SUBMISSION to Fast Track Mahitahi Development Application

Directly Affected Adjacent Residents Submission

Peter Olorenshaw & Julie Jones

Date: 25/6/25

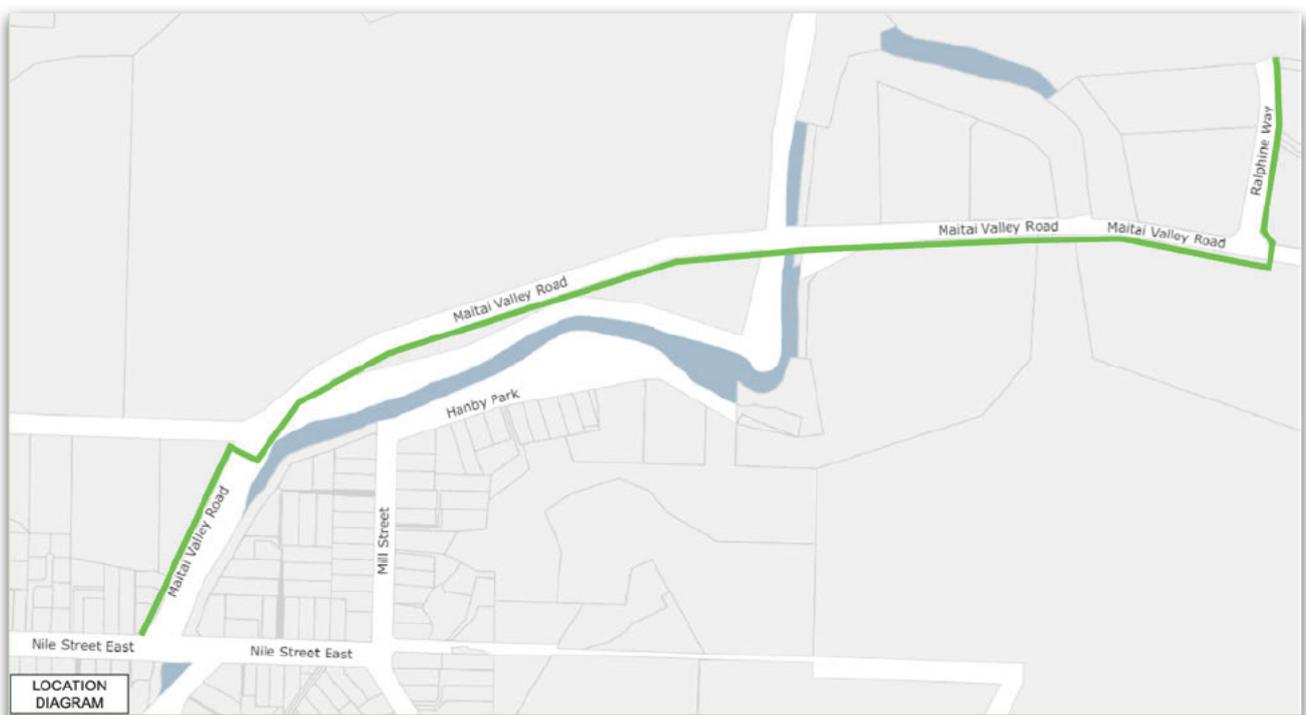
2. 1 Directness of Cycle Routes is one of the core principles of encouraging active transport (eg <https://eucg.eu/2020/05/29/how-to-develop-cycling-infrastructures-learning-from-the-dutch-example/>). Peter has been the convenor of Nelson Transport Strategy Group (Nelsust) Inc. since 2008 and has extensively researched sustainable transport in general and encouraging active transport in particular. The proposed route for cycling is the opposite of the principle of directness in taking people away from the intended destination of commuting to town, up and over a hill and involves crossing the hazardous to cyclists Maitai Valley road twice and the river twice before getting back to the same side of the road and river as you could have been on with the direct route around the back of Dennes Hole. Peter measured it on top of the South Maps and its 1/2 a km longer and involves climbing up from 17 m to 33 m. And at best alongside or on

what will become busy roads of Ralphine Way and the Maitai Valley Road. In comparison, it could be fabulous biking around Dennes hole and through Branford park to get directly to the proposed shared path at the beginning of the Maitai Valley Road, away from motor vehicles altogether for the most part and on a much shorter route. The Pink on the map is proposed, the red where it could, should and must go.

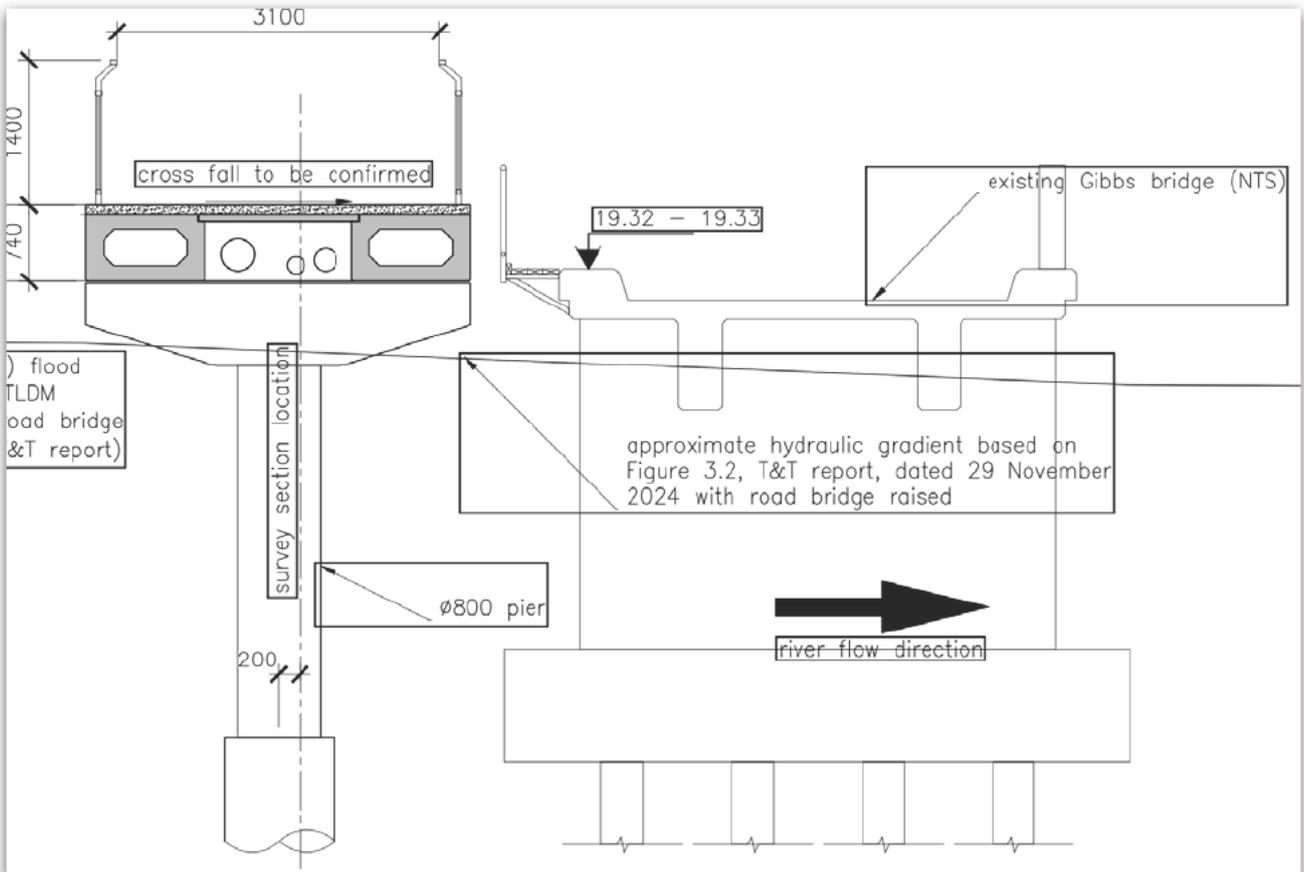
2.5 Biking up Maitai Valley Road past the bridge near Ralphine Way is not pleasant - the route is narrow and winding with poor visibility it is scary for cycling. The cycle bridge across the river here is not necessary or useful as most people biking up the valley will turn off before Gibbs bridge and use the new cycleway alongside the river around the back of Sunday Hole to travel further up the valley.
